## City of Ketchum

### **Recommendation To Approve Change Order #4 to Contract 20454**

Project Description: Fire Station CM/GC

Change Order #:004

1 FLOOR FINISH PLAN - LEVEL 01  
SCALE | 1/8" = 1'-0"

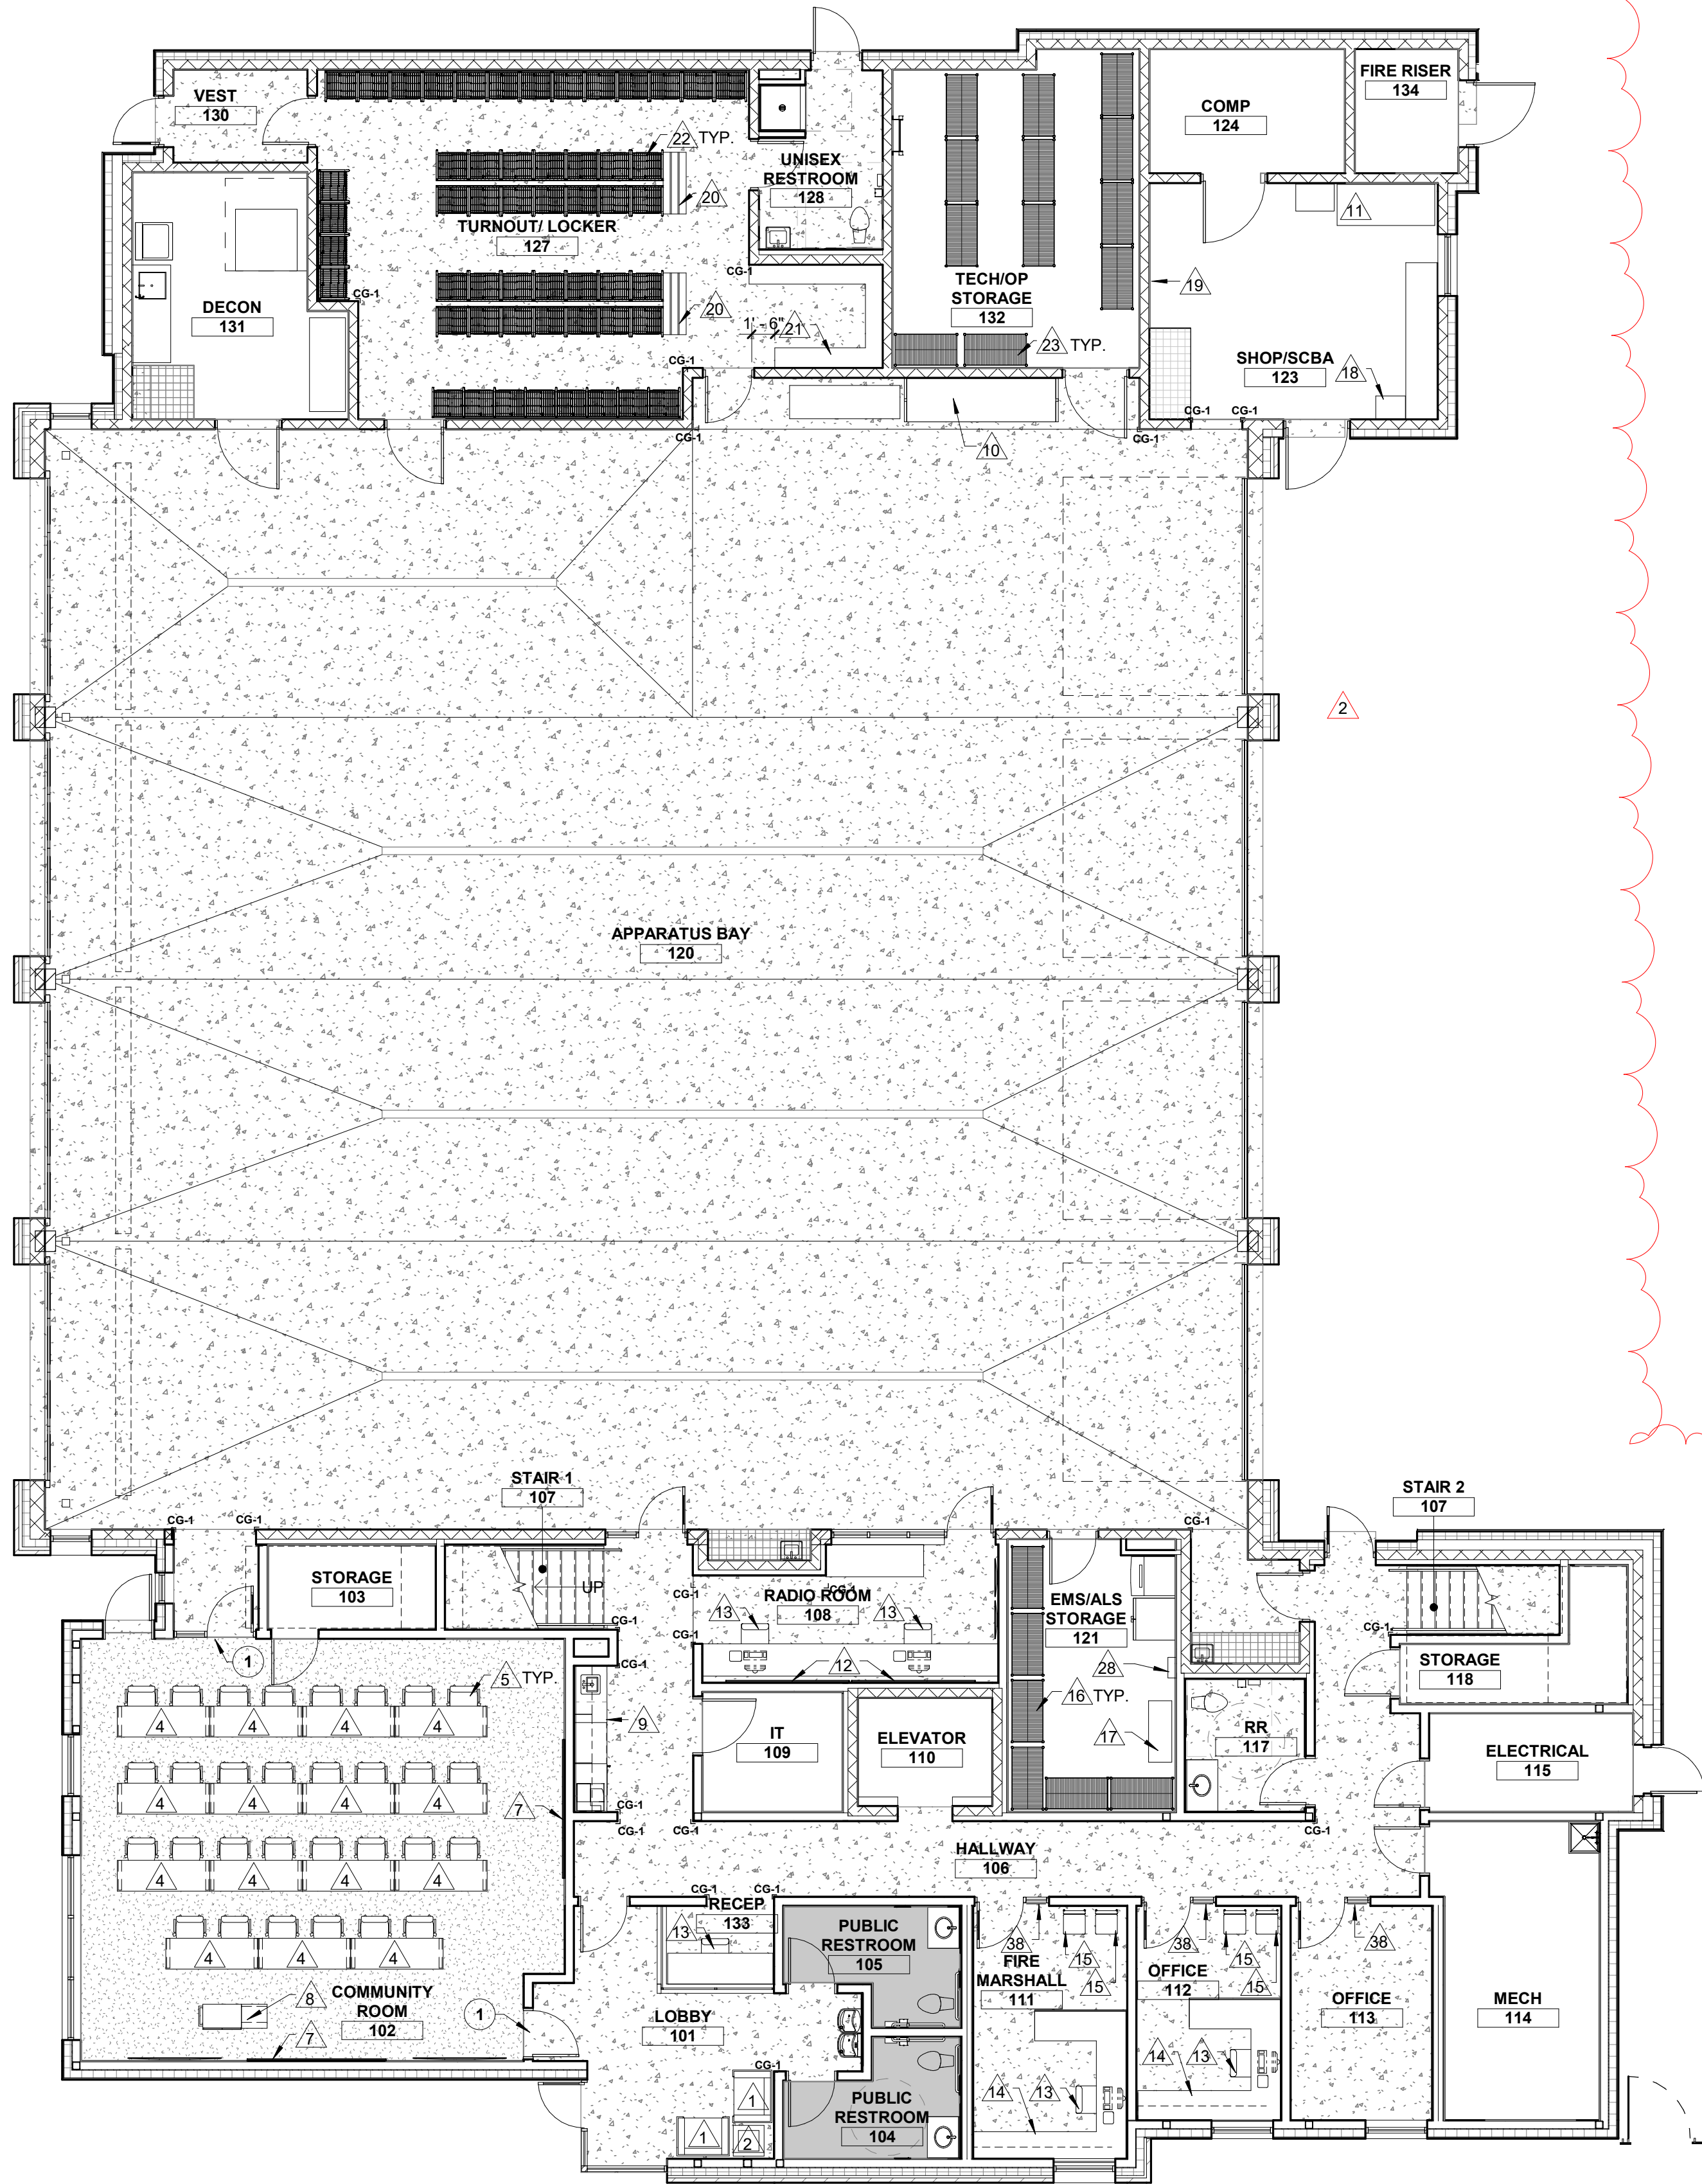
Per the VA Log the option to remove the polished concrete and change to sealed concrete has been accepted at the Apparatus Bay 120, see attached marked up A6.01, Please provide confirmation.

Provide pricing for the following two options for owner to review:

**Option 1:** All polished concrete to be 800 grit, as per spec and updated drawings.

**Option 2:** Polished concrete to be 400 grit in only the App Bay 120 and Turnout/Locker Room 127. The rest of the rest of the polished concrete to be 800 grit.

**INTERIOR ELEVATION - LAUNDRY 210 - NORTH**

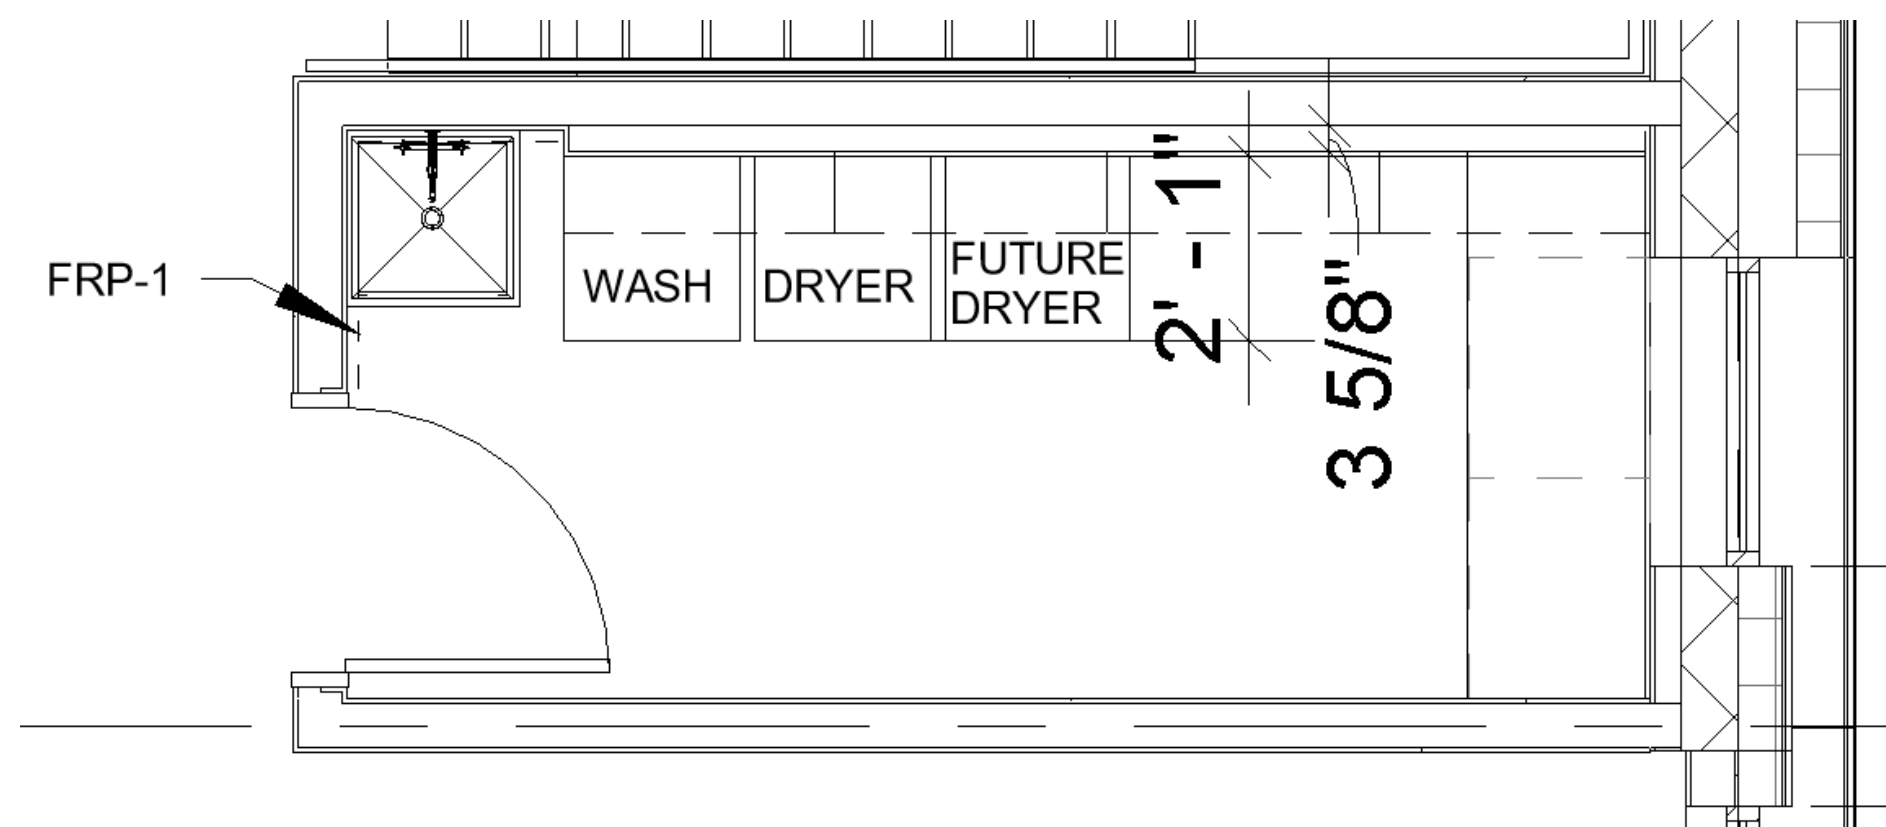
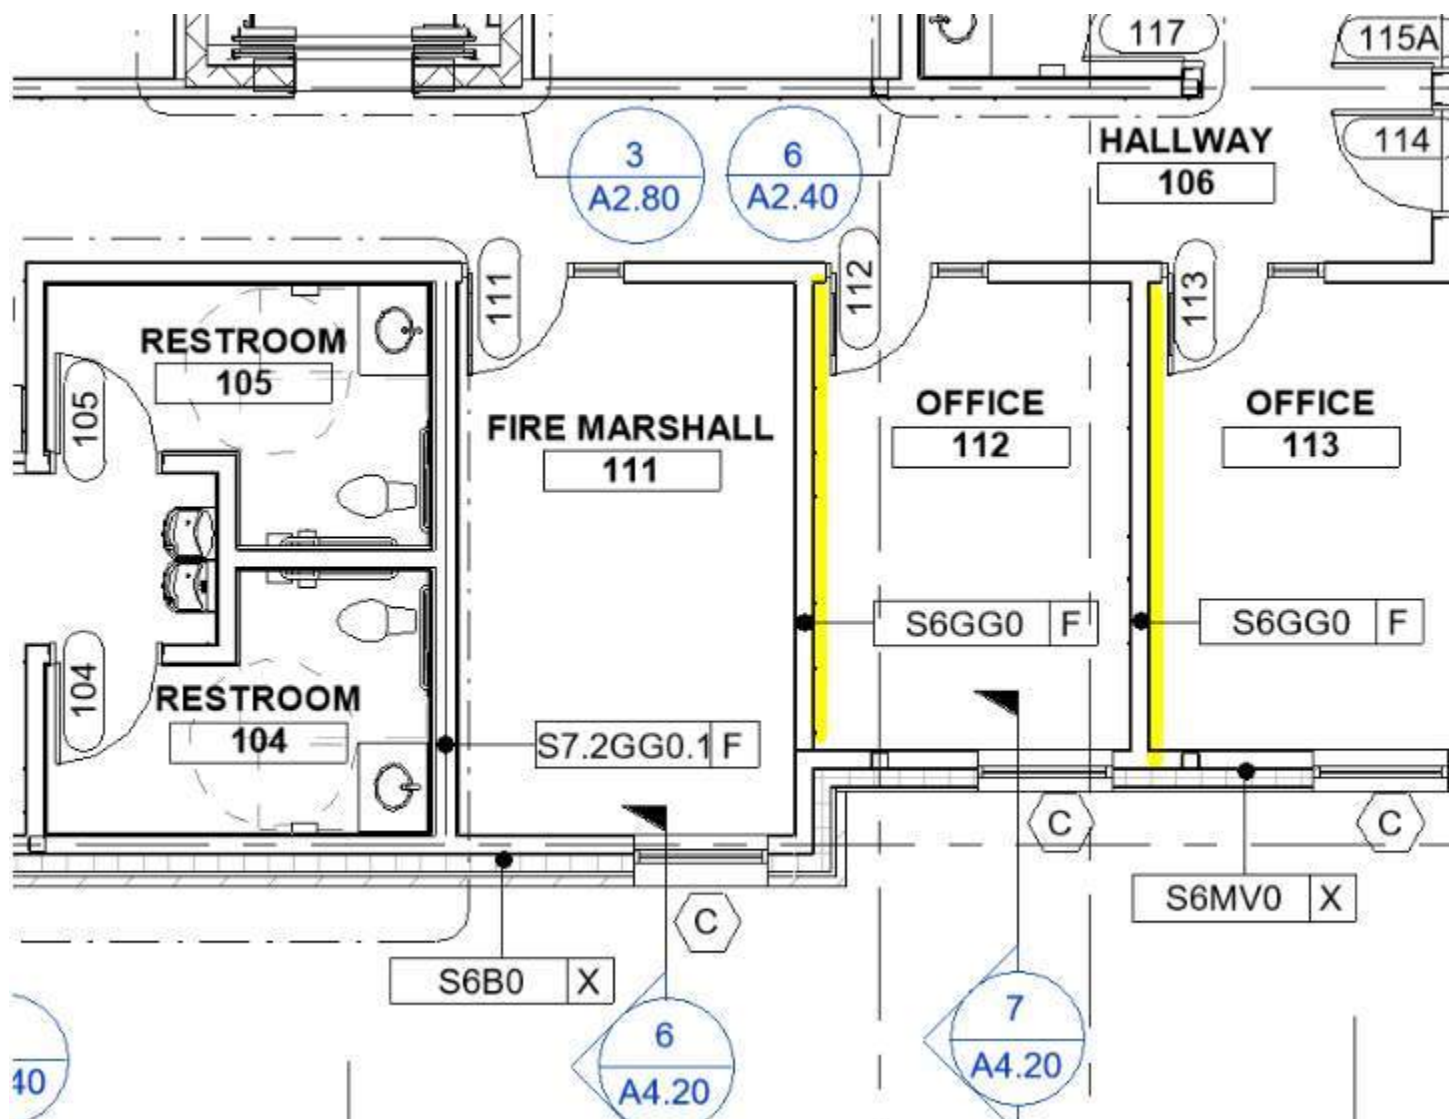
Description: Added GWB at Offices & Laundry Wall Furring for Plumbing

**DIMENSION PLAN -  
LEVEL 02**

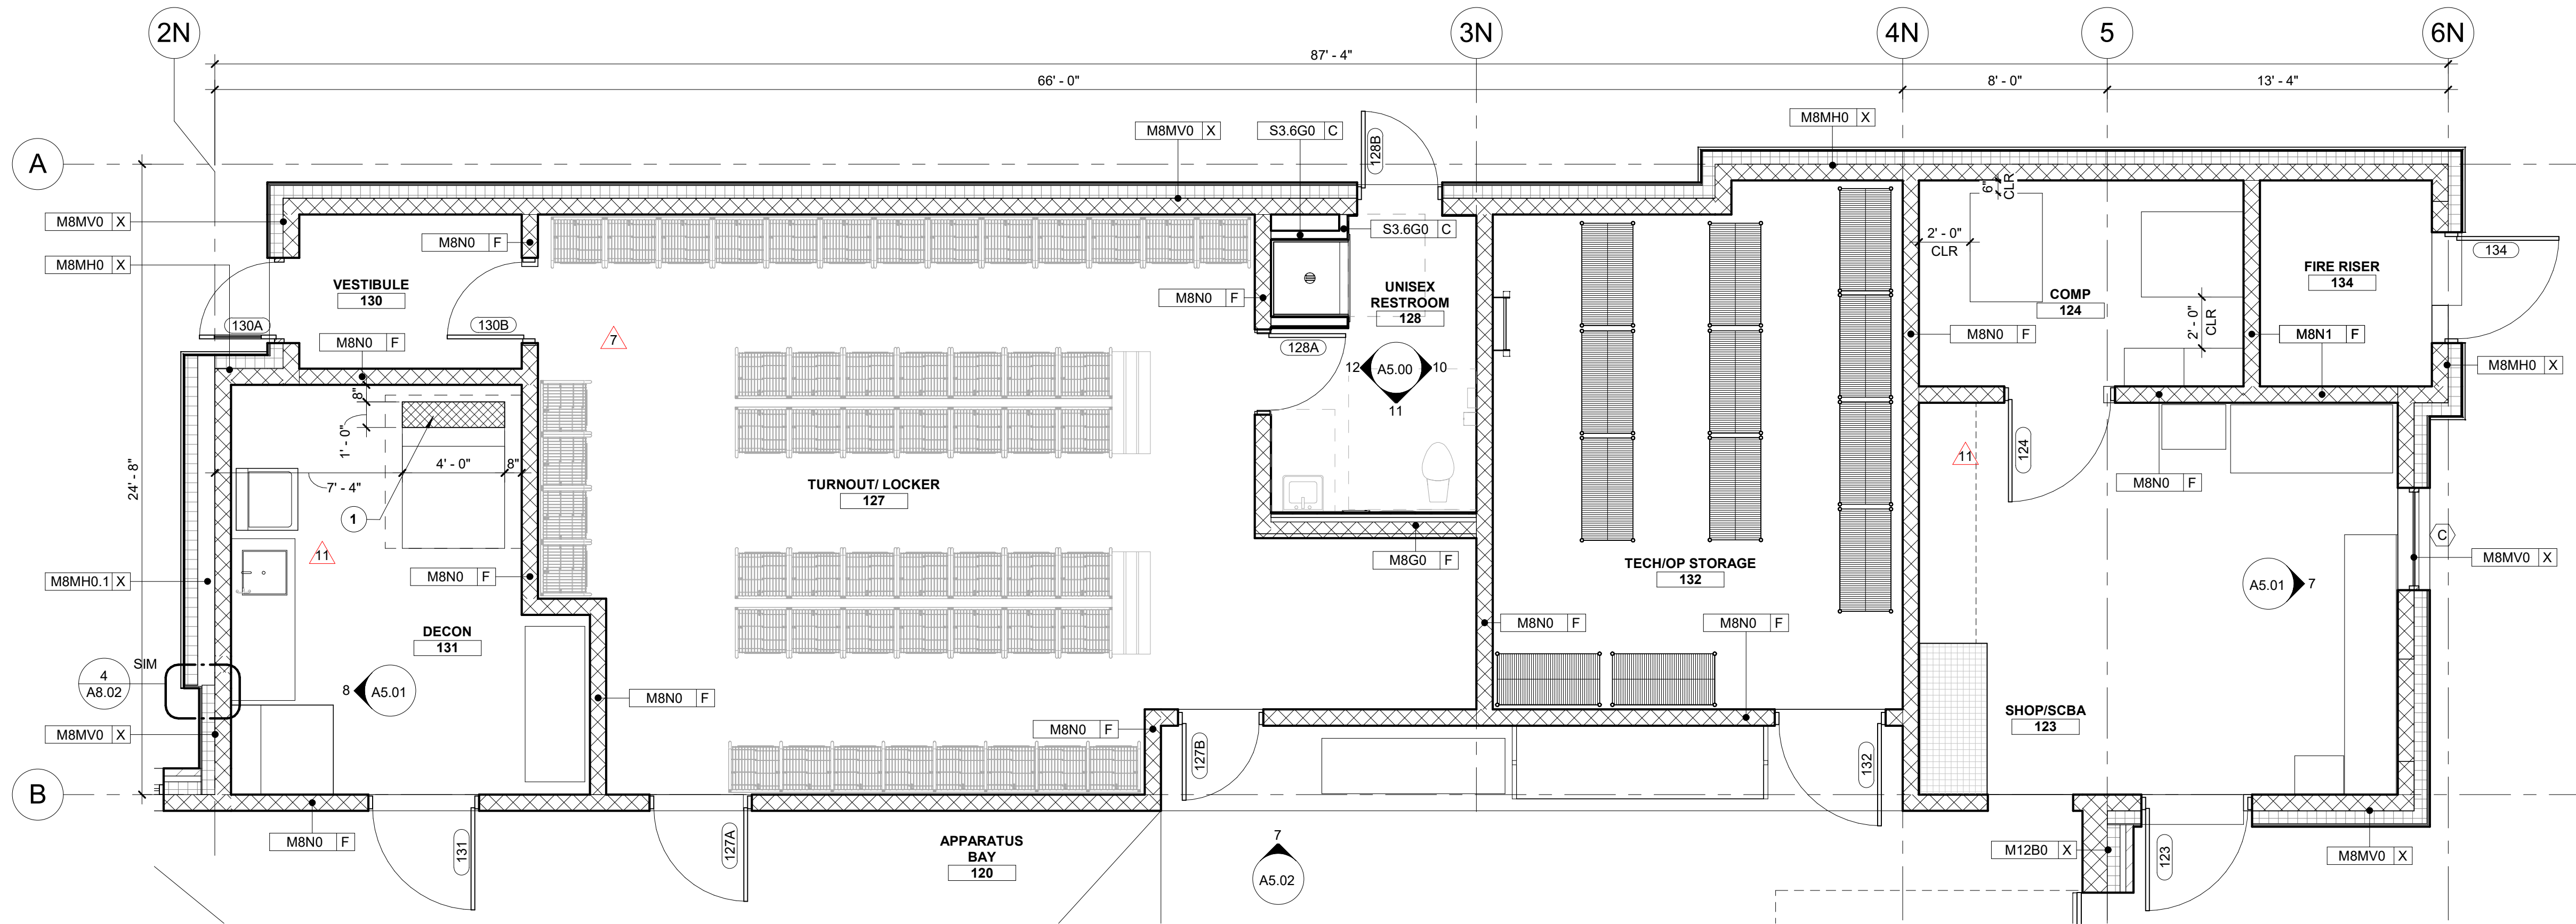
- 1) A2.02 – FLOOR PLAN – LEVEL 02
  - a) Added sink back into the kitchen island in Kitchen/Day Use 201.
- 2) A2.22 – DIMENSION PLAN – LEVEL 02
  - a) Added sink back into the kitchen island in Kitchen/Day Use 201.
- 3) A2.40 – ENLARGED PLANS
  - a) #4 – ENLARGED PLAN – KITCHEN
    - i) Added sink back into the kitchen island in Kitchen/Day Use 201.
- 4) A5.01 – INTERIOR ELEVATIONS
  - a) #11 – KITCHEN/DAY USE 201 ISLAND – NORTH
    - i) Added sink back into the kitchen island in Kitchen/Day Use 201.
- 5) A7.00 – ROOF PLAN
  - a) Added dimensions to roof ladder location per response to RFI #CC-133.
